**CAMSHAFT TICK NOISE—3.0L 4V ENGINE ONLY
WITH EXHAUST CAMSHAFT DRIVEN WATER PUMPS**

TSB 08-3-10

This article supersedes TSB **07-13-10** to add a production fix date.

Figure 1 - Article 08-3-10

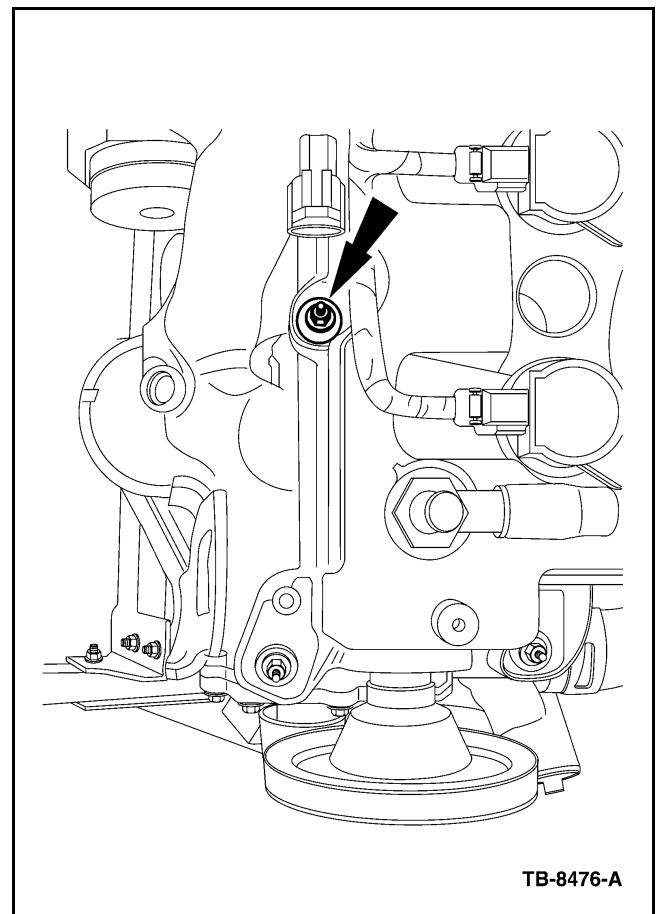
To diagnose, with the engine running and warm (normal operation temperature), using a mechanic's stethoscope, determine if ticking noise is coming from the left hand exhaust camshaft at cylinder number 6 (Figure 1). If ticking noise can be verified, refer to the following Service Procedure.

Figure 2 - Article 08-3-10

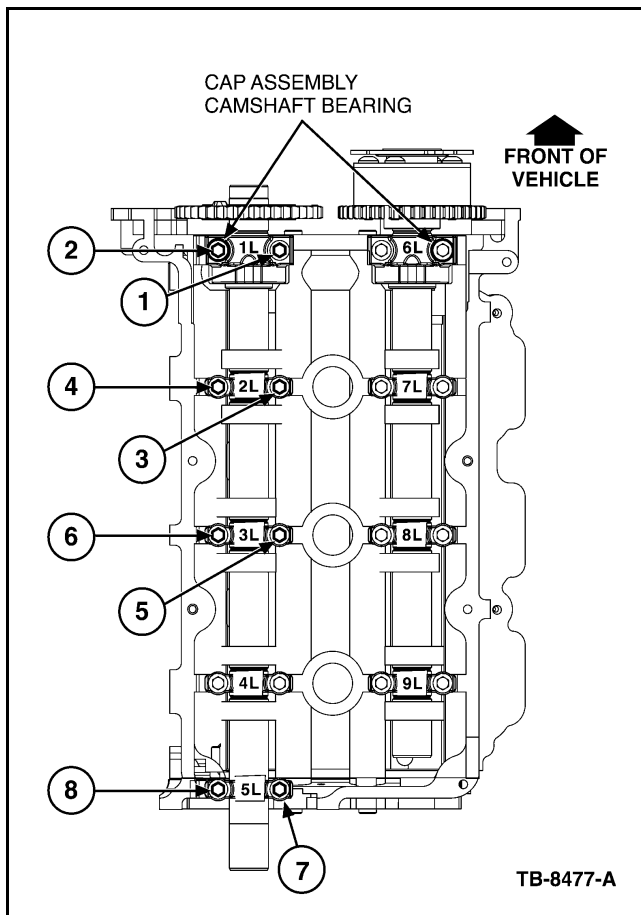
1. Remove the left hand camshaft cover. Refer to WSM, Section 303-01 of the appropriate manual.
2. Rotate the engine clockwise until the cylinder number 6 exhaust cam lobes are pointing up and the valves are fully closed.
3. Remove all left hand exhaust cam caps individually and reinstall them finger tight.
4. Torque bolts in sequence as shown in Figure 2, to 72 lb-in (8 N•m) excluding cam cap number 4L camshaft cap.

Figure 3 - Article 08-3-10

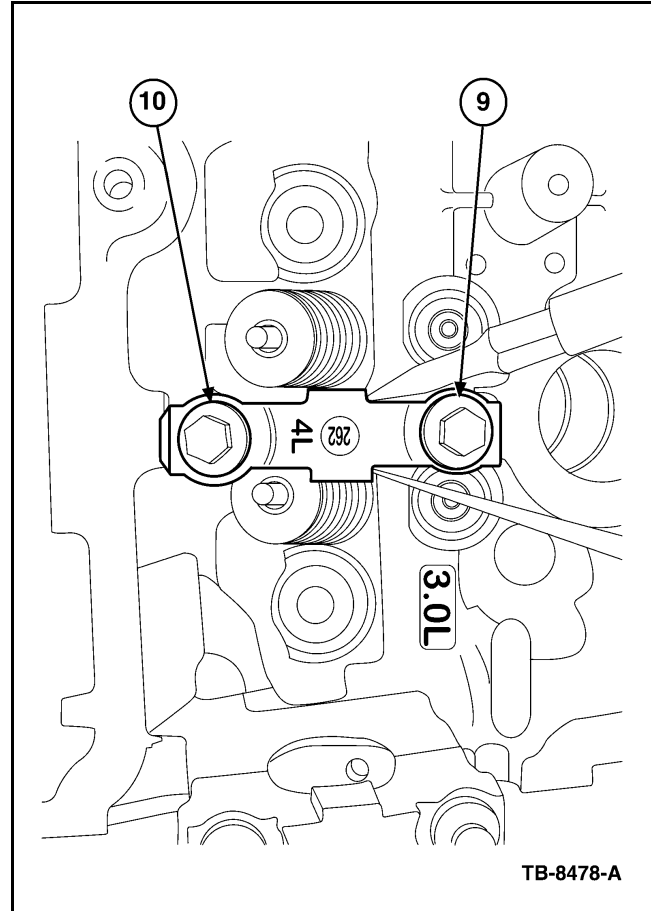
5. Using a screw driver positioned on each side of the top of cam cap number 4L (Figure 3), apply hand pressure and shift cam cap number 4L toward the exhaust side of the cylinder head.

6. While holding cam cap number 4L in the shifted position, torque the fastener number 9 (inboard) first, to 72 lb-in (8 N•m) then torque fastener number 10. (Figure 3)
7. Install the left hand camshaft cover. Refer to appropriate WSM, Section 303-01.
8. Fully warm the engine to verify the repair.
